Appendix C:

Project Correspondence

This appendix contains correspondence regarding the Long Bridge Project.

Figure 1 – Conceptual Alternative Tunnel Alignments 14th Street Bridges (incl. WMATA and CSX)

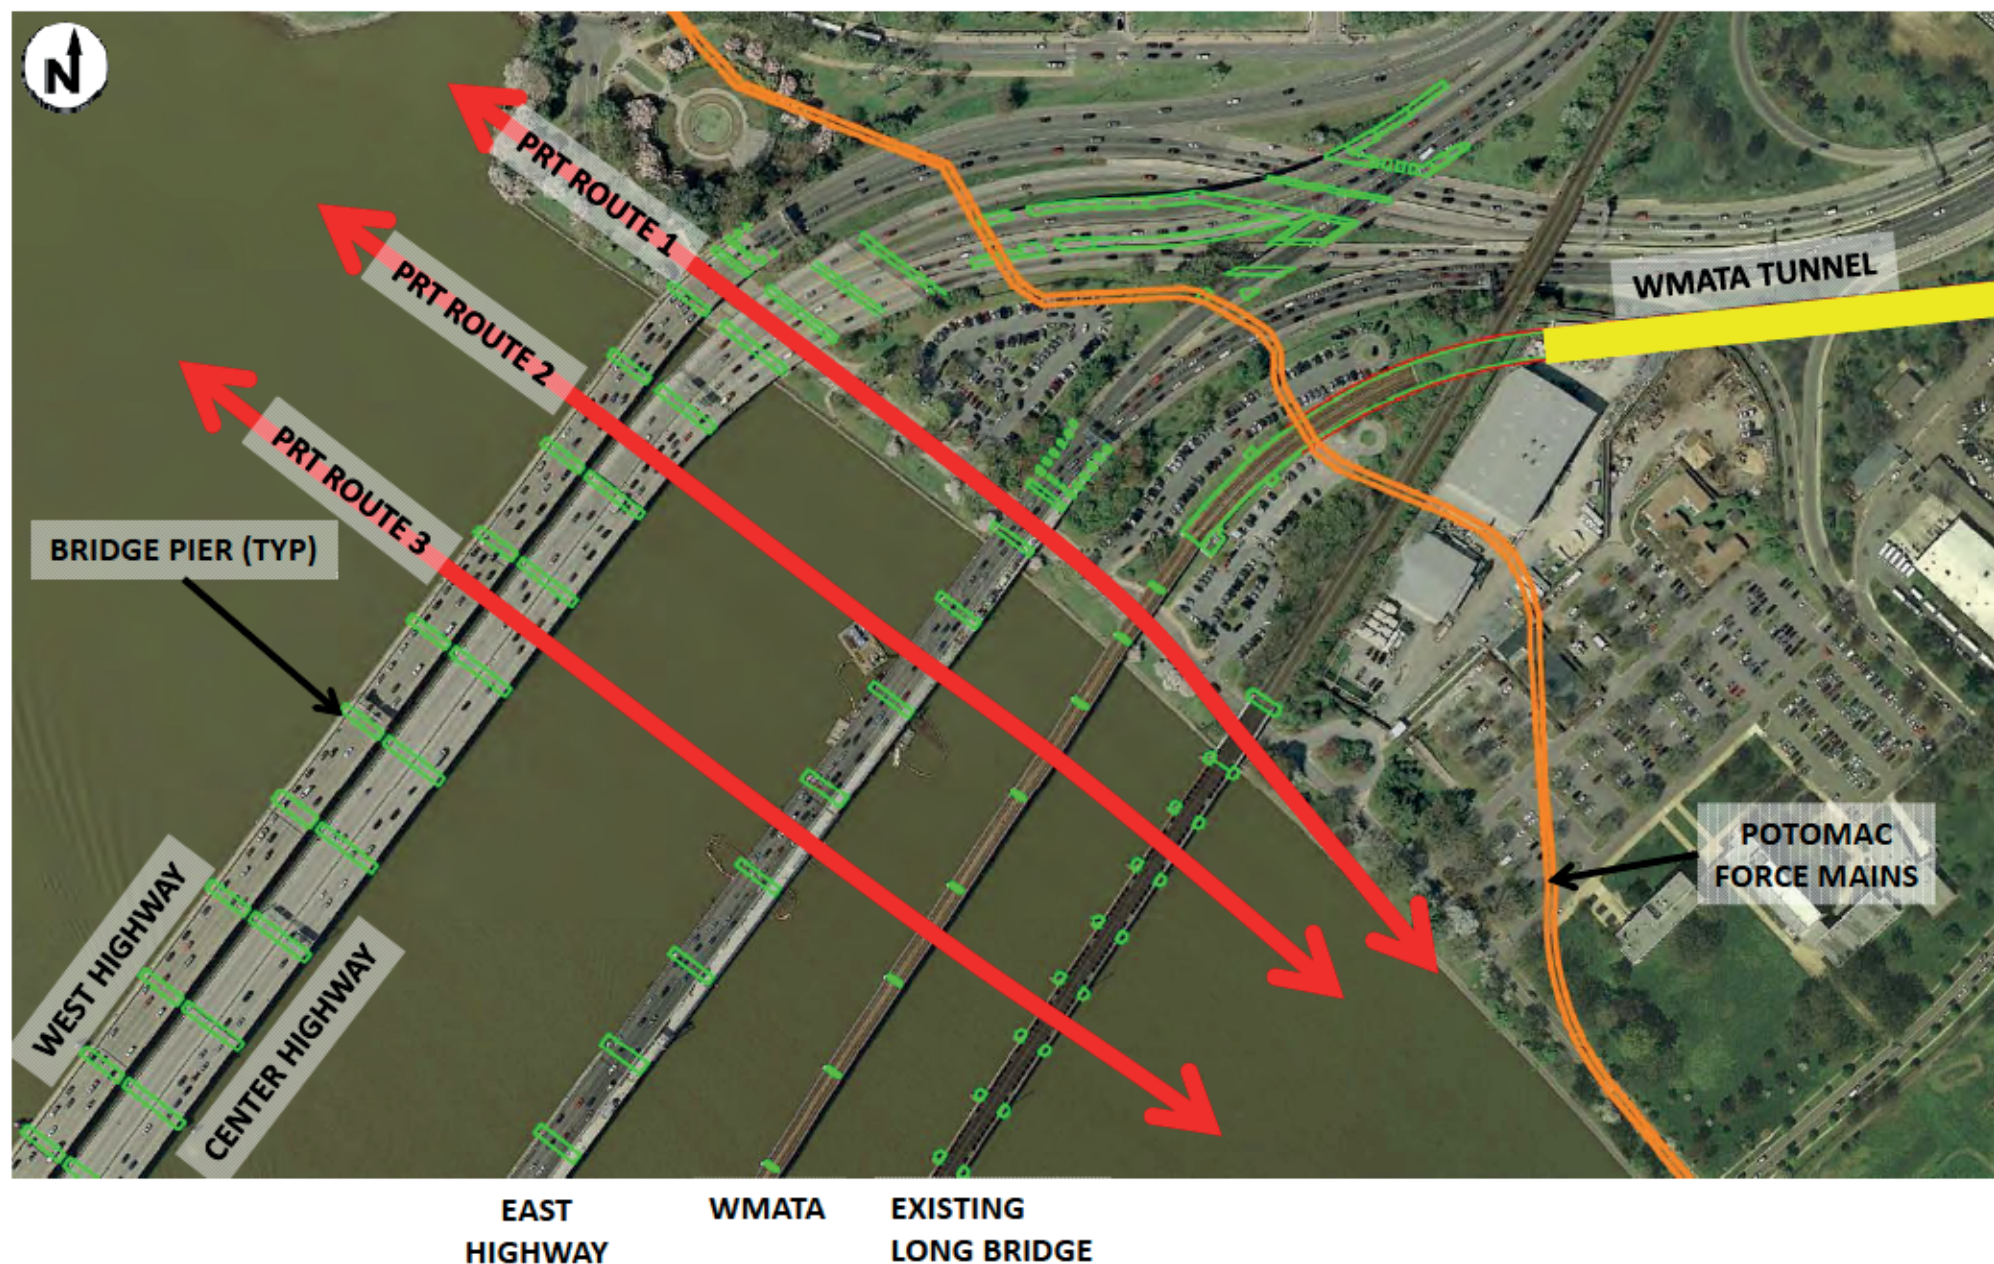
The Potomac River Tunnel (PRT) Project, currently in the planning phase, is the portion of the DC Clean Rivers Project which will provide control for CSOs along the Potomac River, which are generally between the Lincoln Memorial and Georgetown. The PRT will consist of a storage/conveyance tunnel and supporting infrastructure, including diversion facilities connecting to existing sewers, drop shafts, overflow structures, and ventilation control facilities. DC Water, as co-lead agency with the National Park Service, is currently preparing an Environmental Assessment for the PRT project.

The PRT will convey flows captured from the Potomac River CSOs via gravity to the existing Blue Plains Tunnel and Blue Plains Advanced Wastewater Treatment Plant, generally via an alignment parallel to the eastern shoreline of the Potomac River. In the area of the 14th Street Bridges (including the Long Bridge), the PRT must avoid the deep foundations of each of the five existing bridges. Based on preliminary review of record drawings provided by each of the bridge owners, Figure 1 shows potential alignments being considered for the PRT as it passes through the Study Area. Figure 2 includes a cross section showing the PRT potential alignments relative to the existing Long Bridge deep foundations, based on drawings provided by CSX in April 2015. All alternatives included in the Long Bridge Project EIS should consider how any proposed foundations will be coordinated with the potential PRT alignments, potentially including providing piers and piles aligned with those beneath the existing bridges upstream. This includes the bike-pedestrian crossing, which at the meeting was presented as a possible separate project. The vertical alignment of the PRT is largely driven by the elevation of the existing Blue Plains Tunnel downstream, the existing WMATA Blue/Orange/Silver Line Tunnels upstream, and the need to maintain positive slope for gravity flow. As such, the vertical alignment of the PRT will be substantially as shown in Figure 3. The proposed Long Bridge Project and bike-pedestrian crossing alternatives presented in the December 14, 2017 meeting warrant close and early technical coordination with DC Water to determine any possible impacts prior to completing both projects' NEPA coordination.

Figure 3 – Conceptual Tunnel Profile

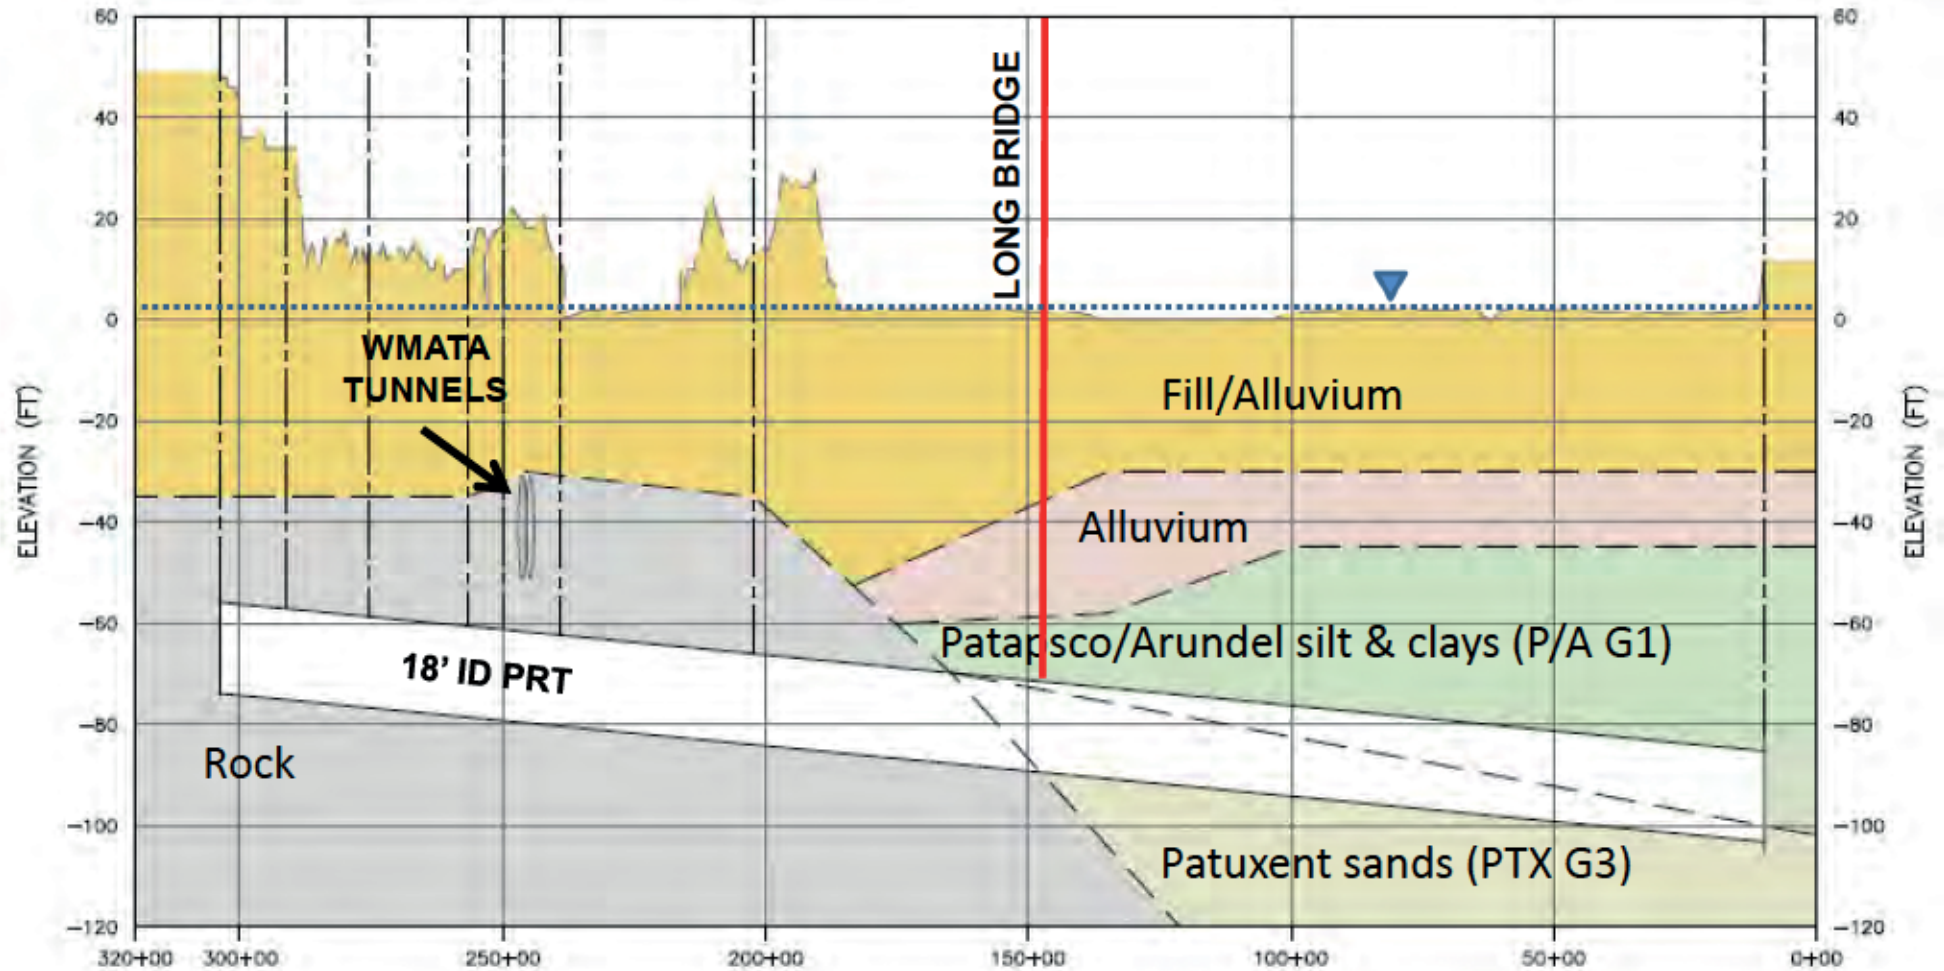
- Original bridge dates back to c. 1809
- Has been rebuilt/multiple times; other piers may exist

STEEL/TIMBER PILES (TYP)
TIP ELEV UNKNOW
